1.1 Motion has been instructed by Great Wolf Resorts (the parent company of Great Wolf Lodge) to advise on highways and transport matters associated with development proposals for a new family resort at a site in Chesterton near Bicester.

GREAT WOLF RESORT, BICESTER - STAGE 1 RSA IN RESPECT OF JUNCTION IMPROVEMENT AT MIDDLETON STONEY

Proposed Junction Improvement at Middleton Stoney

Stage 1 Road Safety Audit  
Requested by Motion

Drawing 1803047-17

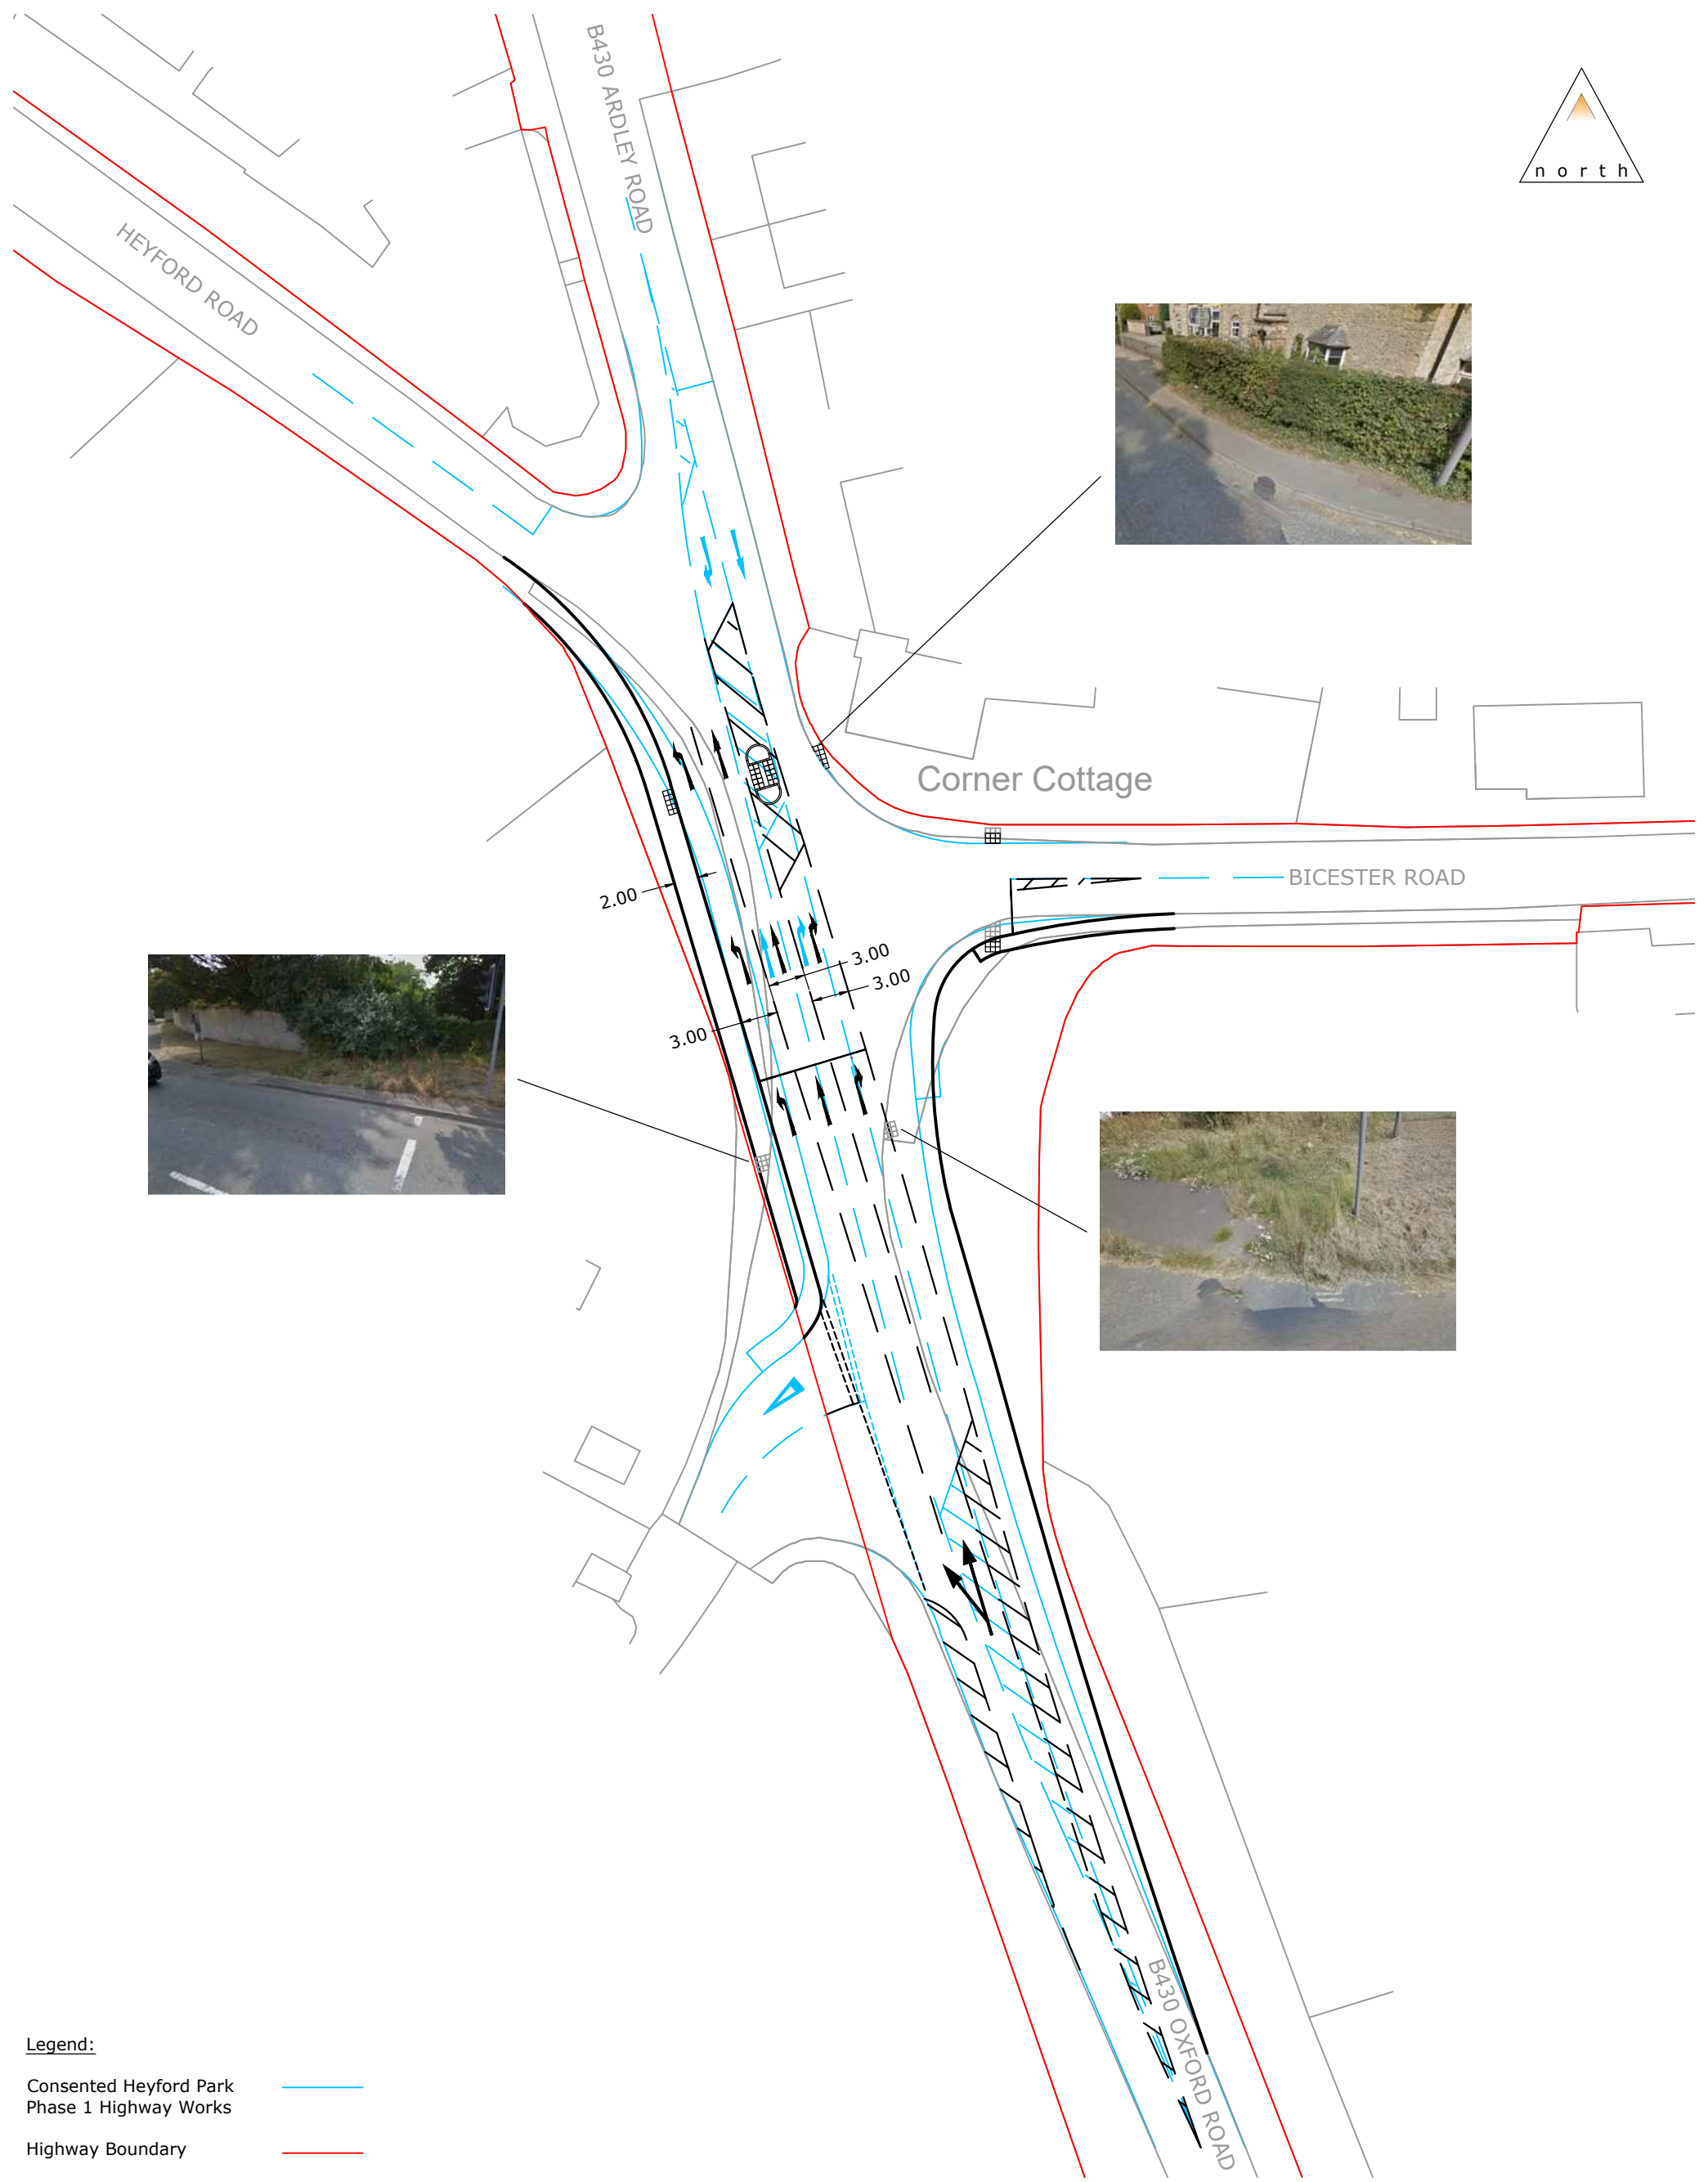
- ▶ OCC queried whether it is likely that all vehicles routing north will switch to the central ahead lane in advance of the stopline and some northbound traffic may remain in the nearside left turn lane and this could result in vehicles merging after the stopline. The mitigation works include changes to the road markings in advance of the northbound stopline. The amended road markings mean that the straight-ahead northbound lane is a continuous lane with the new turning lane towards the B4030 west filtering to the left. Vehicles continuing northbound on the B430 will not be required to change lanes and only the turning traffic (left and right) will be required to switch into the respective turning lanes. On that basis it is considered that the majority of vehicles will be utilising the correct lane at the stopline and it is unlikely that vehicles will be required to merge or change lanes after the stopline. Furthermore, it is considered that signage in the form of dedicated lane advance direction signs (as set out at Section 6 of Traffic Signs Manual Chapter 7) can be installed in advance of the junction to advise drivers the appropriate lane at the stopline and detail of signage will be provided at the detailed design stage;

- ▶ OCC noted that queuing vehicles in the northbound straight-ahead lane could block vehicles entering the proposed new left turn lane. In response, it is highlighted that the junction capacity modelling has been undertaken using LinSig and this assesses the utilisation of the proposed flared left turn lane based on the proposed dimensions and adjusts the utilisation of that lane based on expected queuing in the central lane and the potential for queuing to block access to the left turn filter lane. On that basis, the junction modelling presented in this Note reflects the proposed layout and the likely utilisation of both ahead and the new left turning lane;

The footway width at this location is presently reduced by verge overgrowth and, to a lesser extent, the boundary hedge. Pedestrians waiting to cross would therefore necessarily stand close to the kerb, potentially leaving them vulnerable to a collision with a passing vehicle.

Cut back the verge overgrowth at the back of footway on the east side of Ardley Road, particularly at the proposed uncontrolled crossing. Also trim back the boundary hedge within the highway as far as possible.

Northbound drivers approaching the junction may not be aware of the lane assignment and could make late lane changes, leading to side impact collisions.

Provide a lane designation/destination sign on the northbound approach to the junction.

Drivers turning right into Middleton Park may inadvertently stray into the right turn lane for Bicester Road, leading to heads-on collisions.

On Oxford Road, provide additional road markings (e.g. arrows) and/or road studs between the southbound lane and the right turn lane to enhance legibility of road layout.

Drivers emerging from the private access may not know which traffic stream has priority (a green signal) and could collide with a vehicle passing through the junction.

Provide a traffic signal head on the proposed pedestrian refuge, facing Ardley Road (southbound) but also visible to the drivers emerging from the private access.

- 3.11 The proposed scheme of works has been prepared and is presented at Drawing 1803047-17, attached at [Appendix A](#). The proposed works will be in addition to those consented as part of the Heyford Park Phase 1 and can be accommodated within the existing adopted highway at the junction. The works comprise the provision of an additional northbound dedicated left turn lane at the junction along with minor changes to the south-eastern kerblines and road markings and adjustments to the signal timings at the junction.

5.4	Provide a lane designation/destination sign on the northbound approach to the junction.	Lane designation signage can be provided on approach to the junction and this can be included at the detailed design stage.

5.5	On Oxford Road, provide additional road markings (e.g. arrows) and/or road studs between the southbound lane and	Additional road markings and/ or road studs can be provided and this can be included at the detailed design stage.

the right turn lane to enhance legibility of road layout			
5.6	Provide a traffic signal head on the proposed pedestrian refuge, facing Ardley Road (southbound) but also visible to the drivers emerging from the private access	The positioning of signal heads will be designed at the detailed design stage but it is considered that one can be provided on the refuge island. Position of signal heads on traffic islands is commonplace and is shown, for example, at Figures 7.2.9N and 7.16Na of DMRB CD123.		
5.7	At the detailed design stage, ensure that street furniture will be carefully located/mounted to minimise the risk of vehicle strikes and obstruction of pedestrians/cyclists.	Noted. At the detailed design stage, the positioning of street furniture will consider this.

Drawing: **1803047-TK62** Revision: -

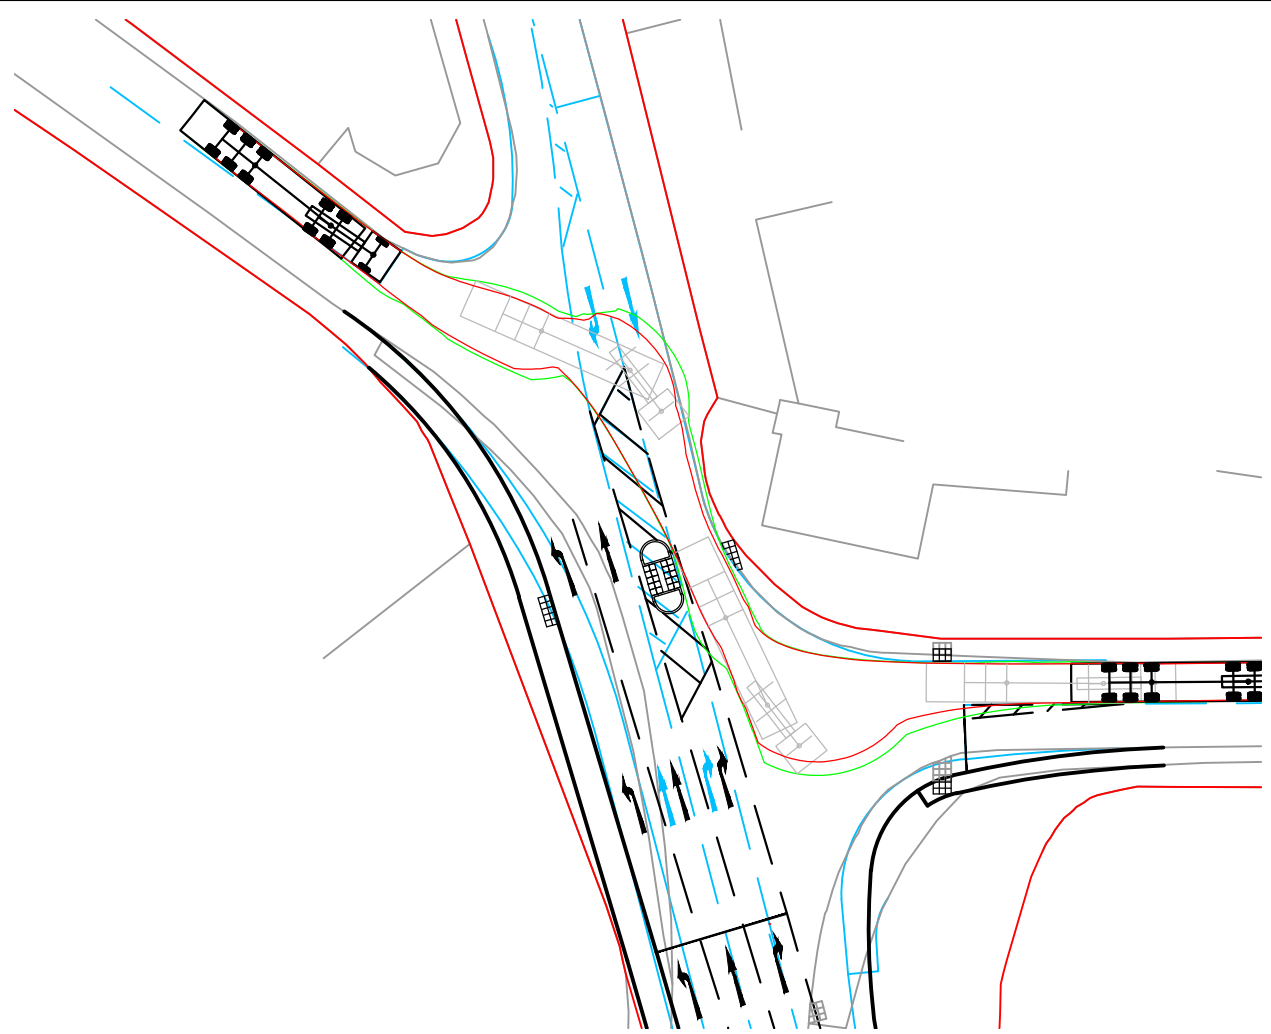
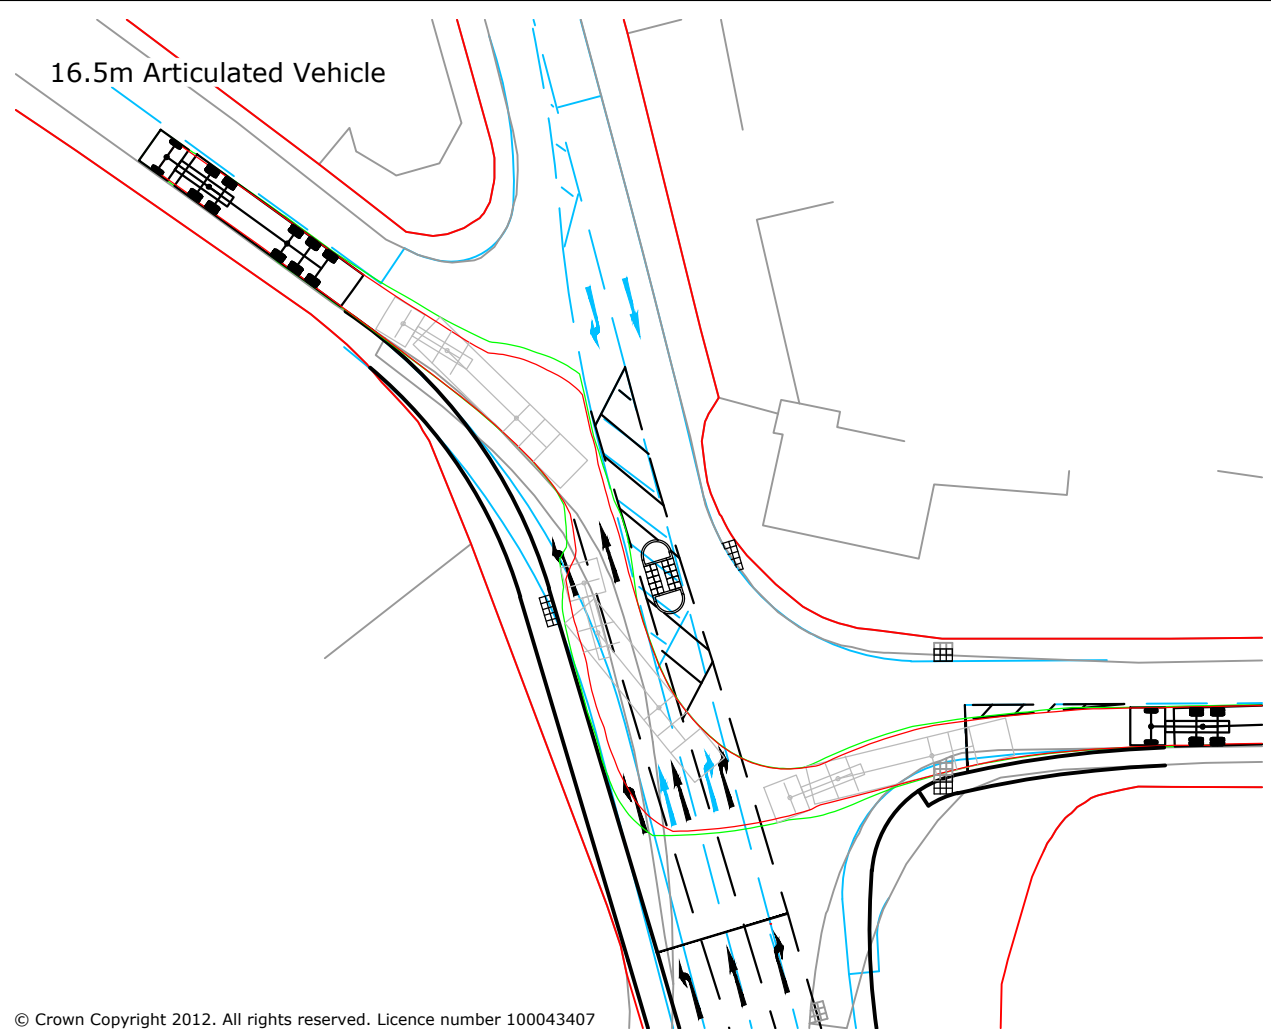
- ▶ As requested by OCC, swept path analysis has been undertaken for HGVs and articulated vehicles routing from the B430 east to west and *vice versa* and this is shown at Drawing 1803047-TK62, attached at [Appendix B](#). The swept path analysis demonstrates that a 10 metre rigid vehicle and 16.5 metre articulated vehicle can manoeuvre appropriately from the B430 east to the B430 west and *vice versa* and will not conflict with the proposed pedestrian refuge; and,
